TECHNICAL SERVICE BULLETIN

Technical Service Bulletin: 310-1070

Forest River is alerting you to an issue involving certain 2018 through 2020 Coachmen Mirada - MDA32SS Class A Motorhome recreational vehicles. Please see the information below which describes the issue and provides you with details on the steps you should take to have your vehicle repaired.

Slide Repair Guide

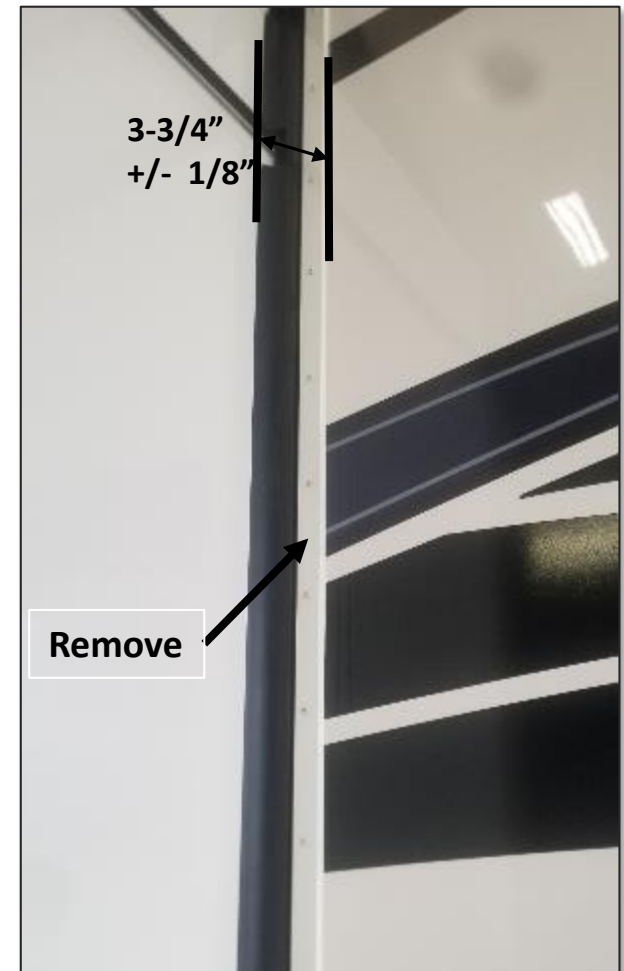
4. ATTEMPT TO REPROGRAM THE SYSTEM PER THE PROCESS SHOWN IN THE LINKED VIDEO.

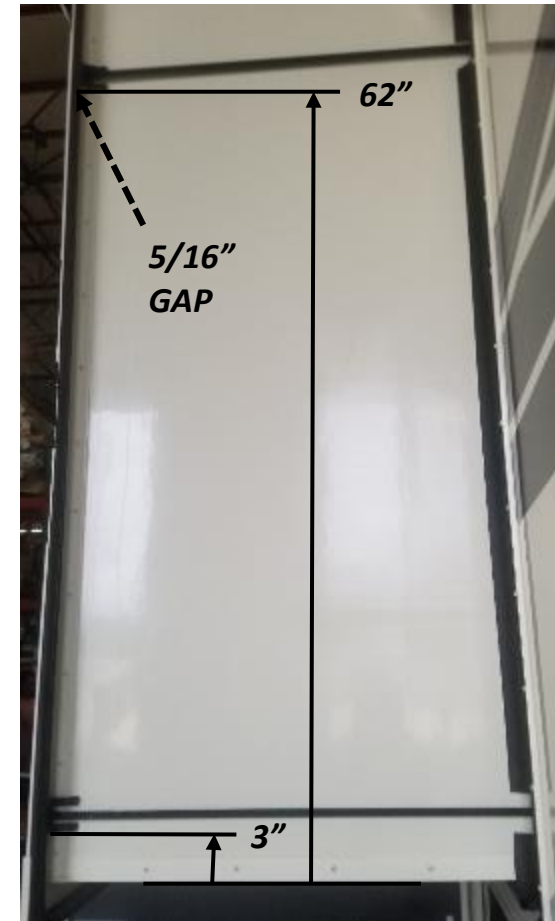
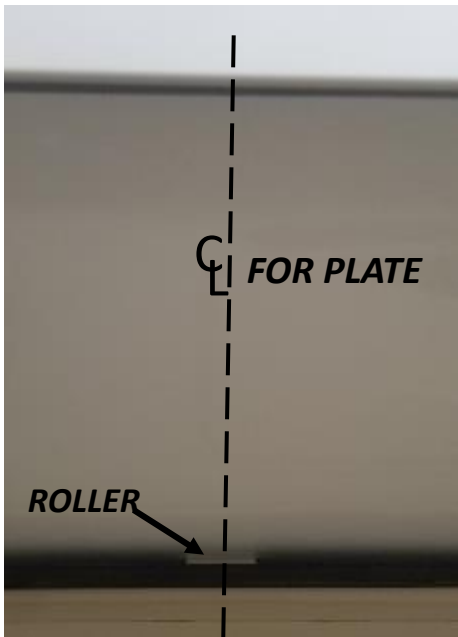
5. VERIFY THE SLIDE COLUMN CLEARANCES. IF COLUMNS ARE NOT MEASURING TO THE SPEC OF 3-3/4" +/- 1/8" FROM COLUMN TO ENDWALL THEN COLUMNS NEED RELEASED. TRIM COVERS WILL BE INSTALLED OVER THE RACK, YOU MAY NEED TO REMOVE THESE TO ACHIEVE AN ACCURATE MEASUREMENT. COLUMNS WILL NEED TO BE UNSCREWED FROM THE SIDEWALL ON THE INSIDE AND OUTSIDE OF THE MOTORHOME. ONLY RELEASE ONE END OF THE ROOM AT A TIME UNLESS INTENT IS TO REMOVE THE ROOM COMPLETELY. FOR SAFETY REASONS ANY TIME A MECHANISM IS LOOSE A SUPPORT DEVICE SHOULD BE UNDER THAT END OF THE SLIDE ROOM. ROOM OPENING MAY NEED GROUND TO REMOVE FLASHING AND ANY BUILD UP ON SLIDE OPENING. ONCE TARGET MEASUREMENT IS ACHIEVED RESECURE RACKS. MEASUREMENTS SHOULD BE TAKEN WITH THE ROOM AT MID STROKE WITH THE ROOM IN TIME TO THE SIDEWALL. MEASURE TOP AND BOTTOM JUST ABOVE OR BELOW OF THE GEAR RACKS.

7. WHILE THE ROOM IS STILL SUPPORTED THE TOP GEAR RACK SHOULD BE RELEASED FROM THE SLIDE ENDWALL. A 5/16" SHIM NEEDS PLACED BETWEEN THE HORSESHOE OF THE GEAR RACK AND T-BAR AT THE TOP EXTERIOR MOUNTING LOCATION ONLY. THIS WILL BE FOR PLACEMENT ONLY AND WILL BE REMOVED. BEFORE RESECURING THE GEAR RACK TO ENDWALL AT THIS NEW LOCATION MEASUREMENTS SHOULD BE TAKEN FOR VERTICAL PLACEMENT. THE HORSESHOE PLACEMENT MEASUREMENTS SHOULD BE AT 3" AND 62" RESPECTIVELY TO THE BOTTOM OF THE HORSESHOES AT THE ENDWALL FROM THE BOTTOM RAIL. THIS WILL ENSURE THAT THE GEAR RACKS ARE RUNNING IN PARALLEL, ADJUST IF NEEDED AND RESECURE.
